SERVICE BULLETIN

#0010

SUBJECT: Amendment to the Sling 2 and Sling 4 Series Annual Inspection

MODELS AFFECTED: Sling 4: All Serial numbers up to and including SN 113,
 Sling 4 Kit: All serial numbers up to and including SN115K
 Sling LSA, Sling 2: SN 236
 Sling 2 Taildragger: All serial numbers up to and including SN 119, 147, 192
 Sling 2, Sling LSA Kits: All Serial numbers up to and including SN 235K

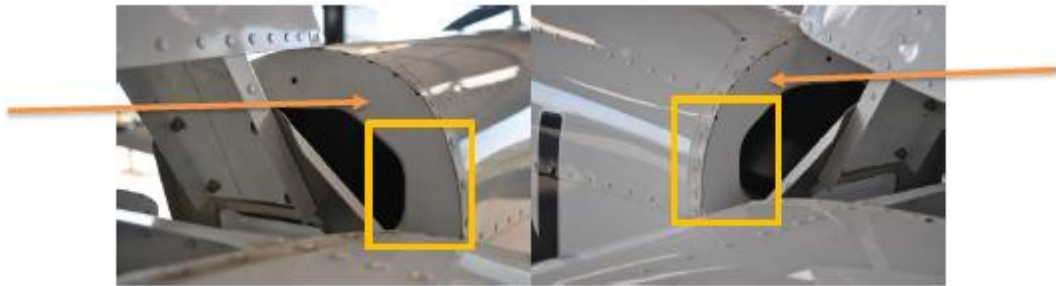
1. With reference to the below pictures, the areas within the yellow boxes on Rib 601 need to be inspected. On Airplane models affected Rib 601 should first be measured for material thickness. If the rib material thickness measures 0.64mm the Service Bulletin needs to be complied with. With a material thickness of 0.8mm this Service Bulletin no longer needs to be complied with. An entry should be made in the logbook stating the Rib 601 meets the material thickness requirement and no further action is necessary.

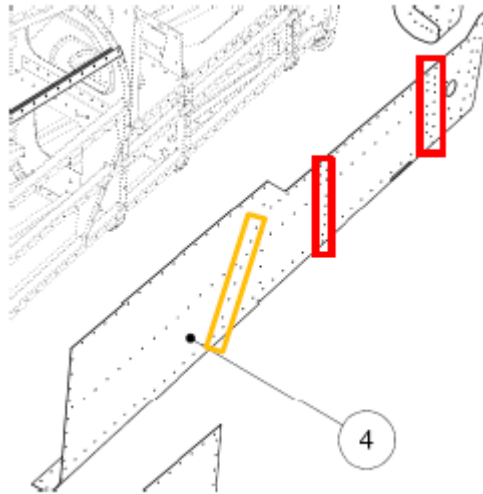
14. Once skin (4) has been removed from the fuselage, follow the line of rivets that attach rib 601 to the rest of the fuselage, de-rivet all these rivets using a 3.2 mm drill bit and pneumatic drill.
15. With reference to the below picture, follow the line of rivets illustrated in the yellow box, de-rivet all these rivets using a 3.2 mm drill bit and pneumatic drill. It should be noted that this has to be done on both sides of the fuselage. The line of rivets should flow from top to bottom going from the rear of the aircraft to the front of the aircraft in a diagonal direction. Once all the rivets that attach the rib and bracket to the fuselage have been removed, the rib and bracket should be easily removed.

20. Rivet each hole with 3.2 mm domed aluminium rivets. It should be noted that with reference to the above picture, the rivets in the red boxes should be rivets of 4 x 10 mm domed aluminium rivets, the exact place of these rivets can be found with reference to the rib 601 & bracket assembly instruction page, and these parts are labelled 3 & 4.

Figure 6: Rib 6 assembly

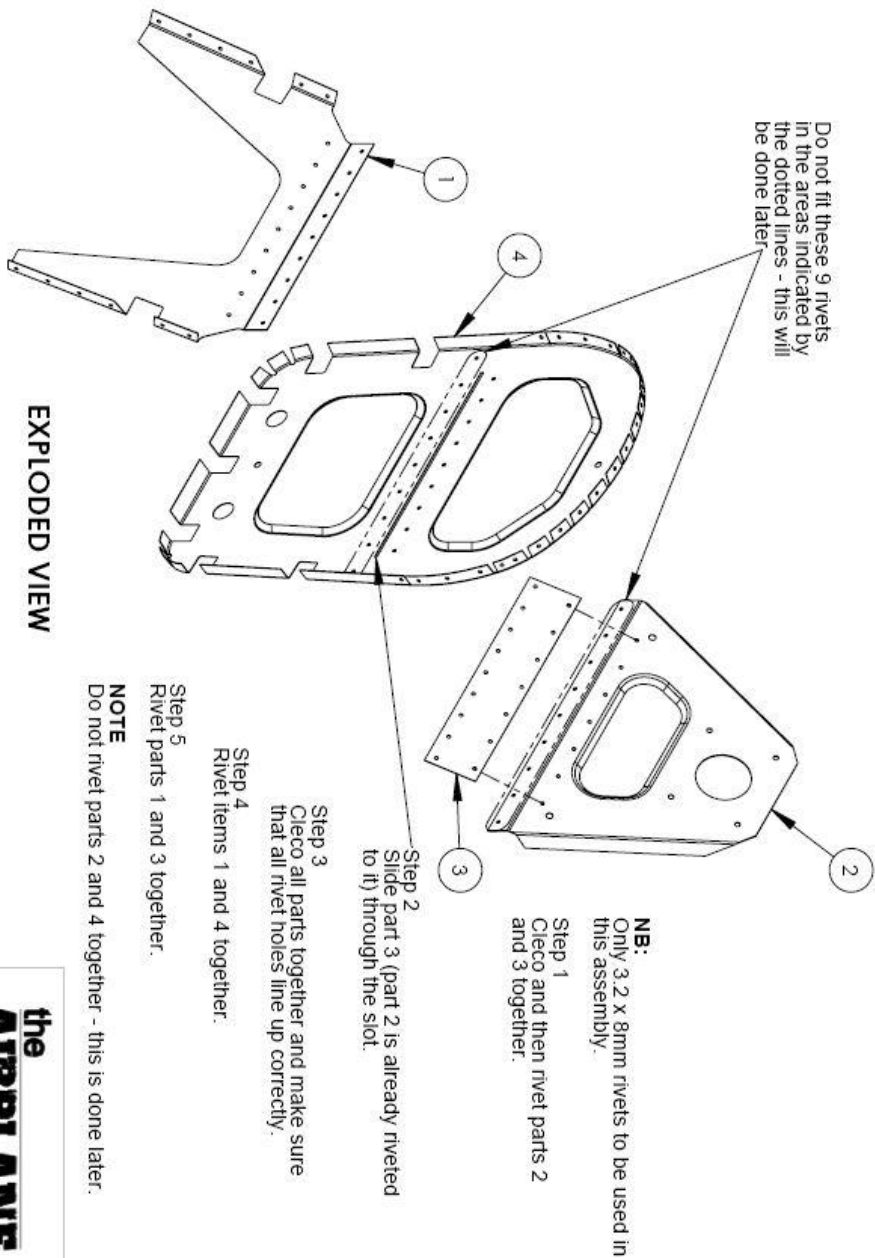
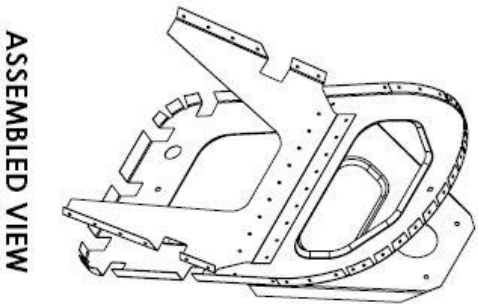
3. Should the rib fail the inspection for cracks being found, the entire rib 601 component will need to be replaced with thicker and stronger material which can be ordered through The Airplane Factory Store.
4. If the rib has failed the inspection the next steps will need to be followed in order to remove and replace the rib.
5. Using the two 3/8" spanners you will need to loosen the two bolts that attach the rudder cables to the rudder. With reference to the below picture, loosen the bolts that are within the yellow circles.

16. It should be noted that the ribs removed from the aircraft should be scrapped and never used on an aircraft again.
17. Once the new part have been assembled with reference to the rib 601 & bracket assembly page, place them in the fuselage as the previous parts were positioned.
